From: [Rael, Rudy E.](#)
To: ["Metro, Steven J. \(Steven.Metro@wilsonco.com\)"](#)
Subject: 7816 Urraca St. NW
Date: Tuesday, November 22, 2016 4:41:00 PM

Based upon the information provided in your submittal received 11/22/16, the above referenced Grading and Drainage plan dated 11/22/16 cannot be approved for Grading Permit or Building Permit until the following comments are addressed:

GRADING AND DRAINAGE PLAN
LOT 5, BLOCK 6, UNIT 19, VCS
ADDRESS: 7816 Urraca Street, NW

GRADING & DRAINAGE PLAN
7816Urraca Street, NW
LOT 5, BLOCK 6, UNIT 19 VCS

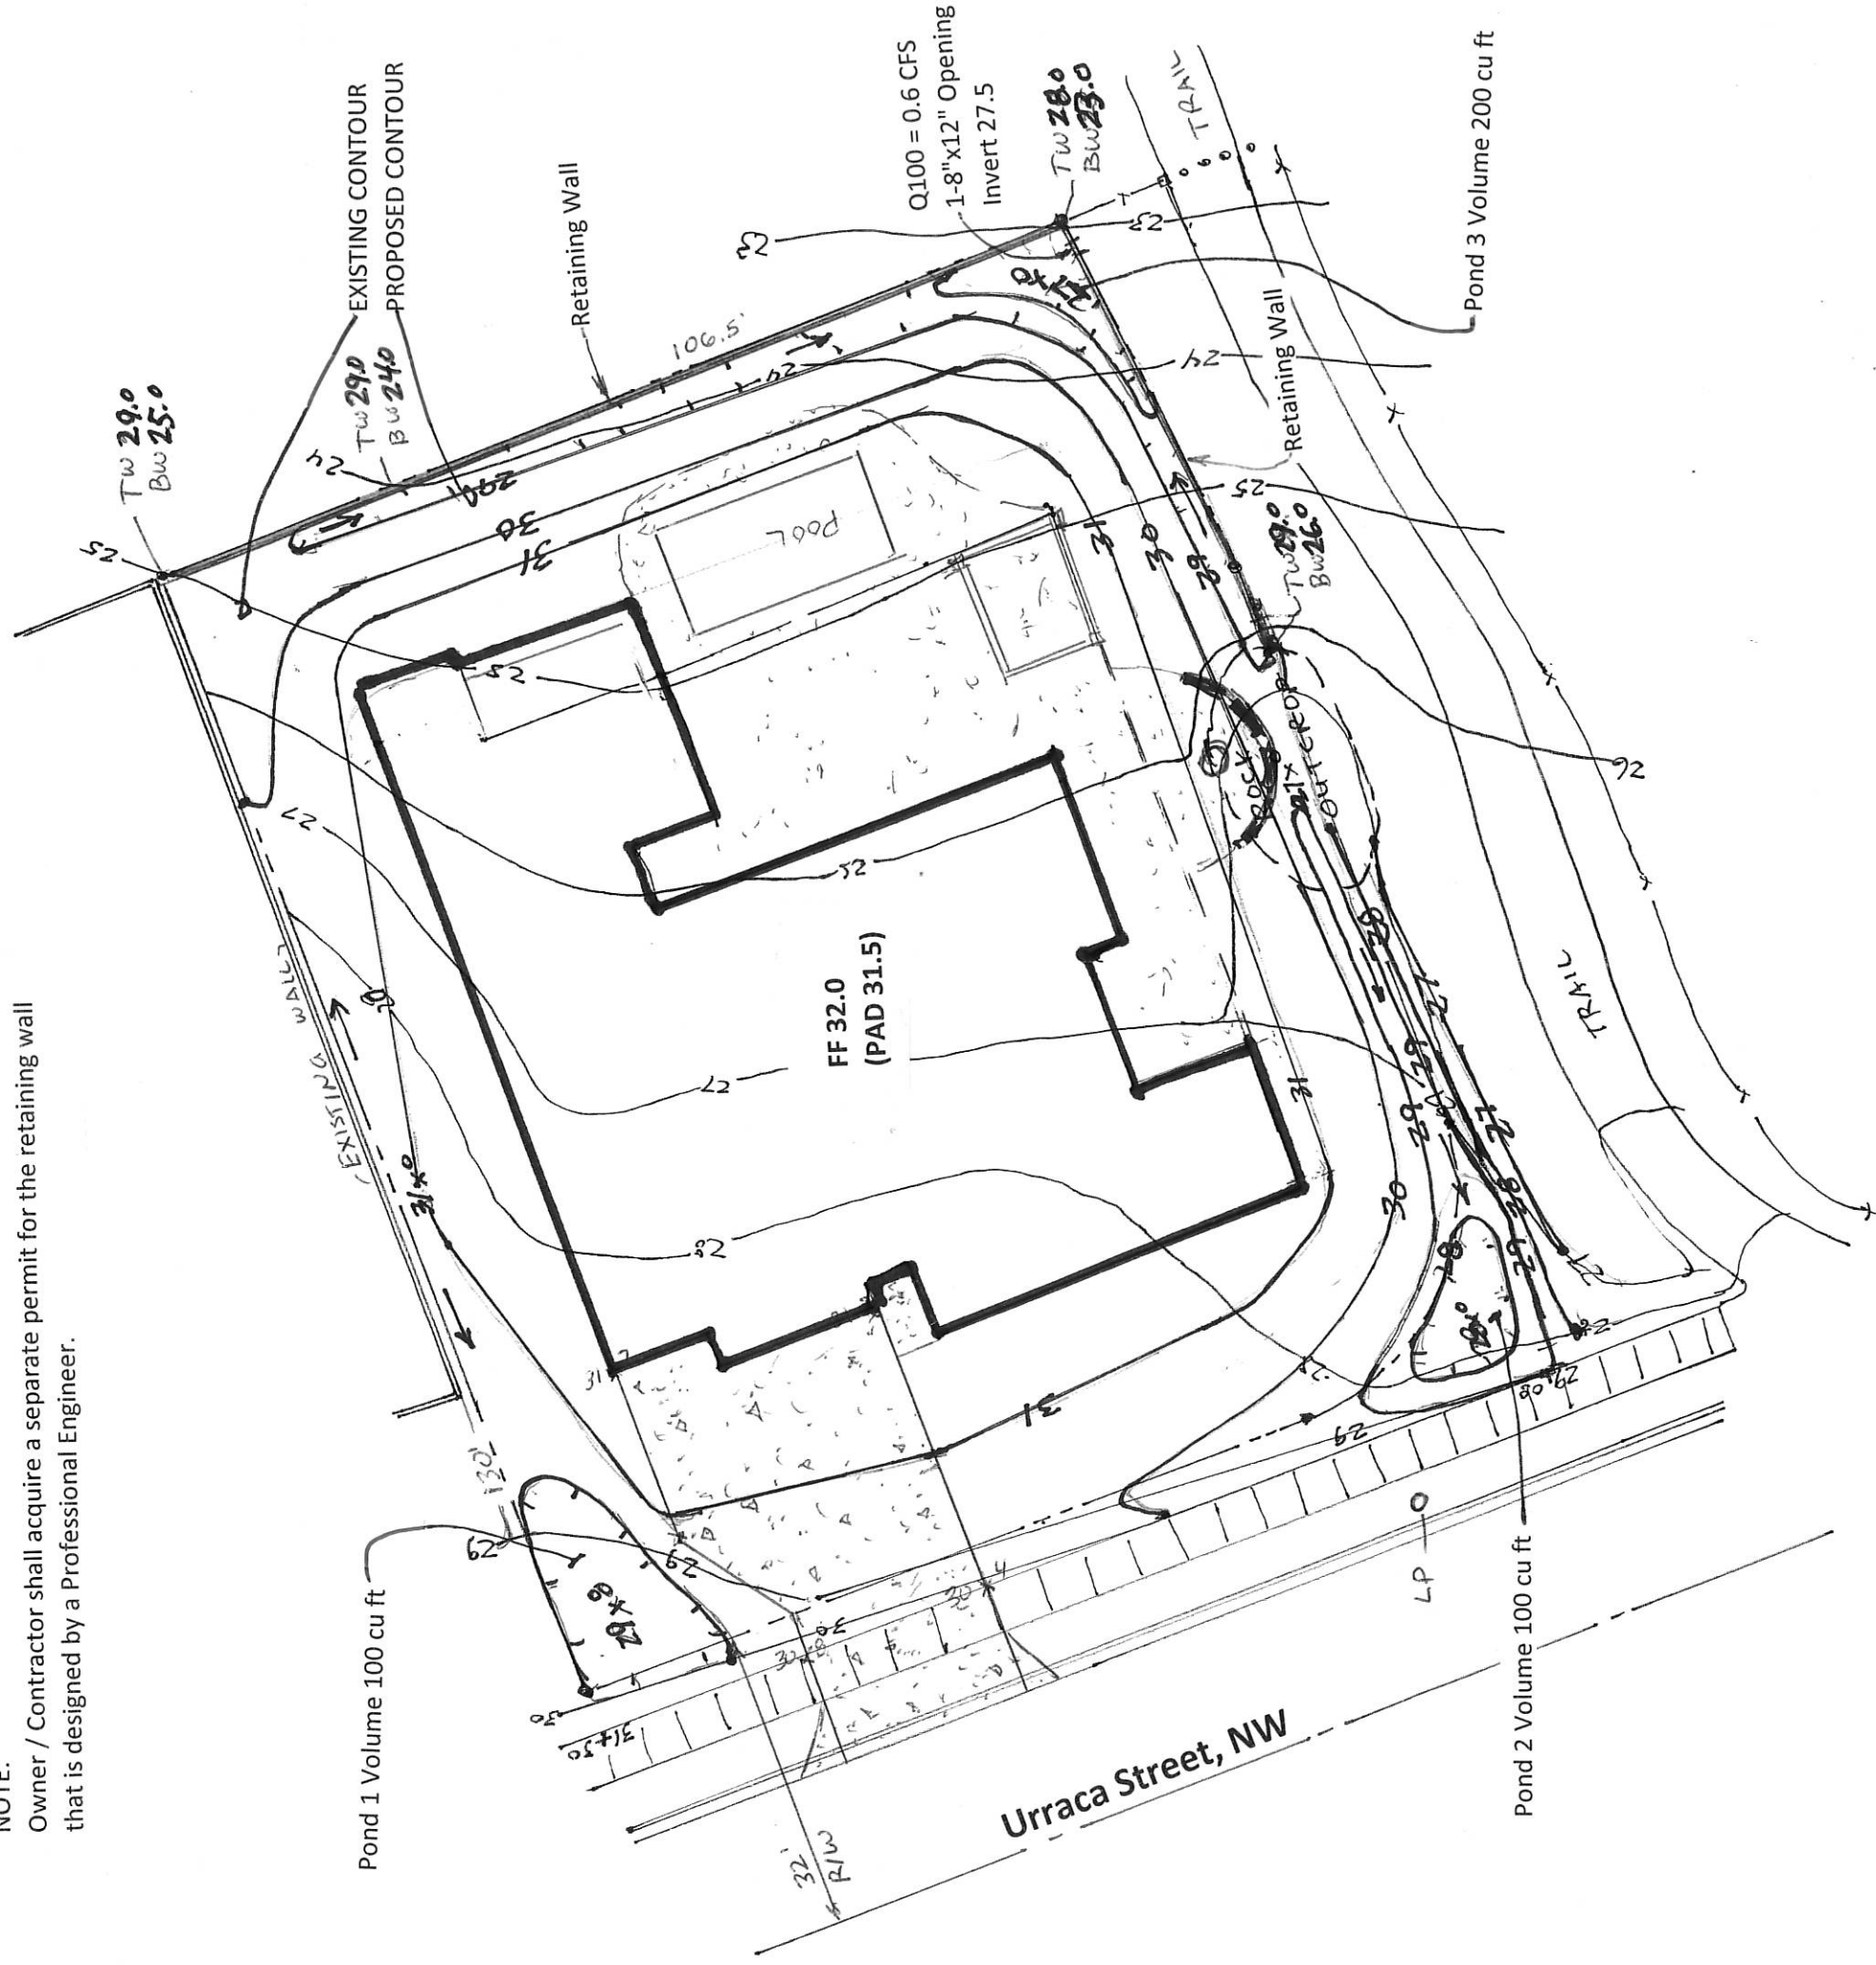
- Provide an opening in the NE corner of the wall if a block wall is to be built.
- Provide a note stating that all walls/fences require a separate permit.
- Provide a note stating that a pad certification is required before slab is poured.
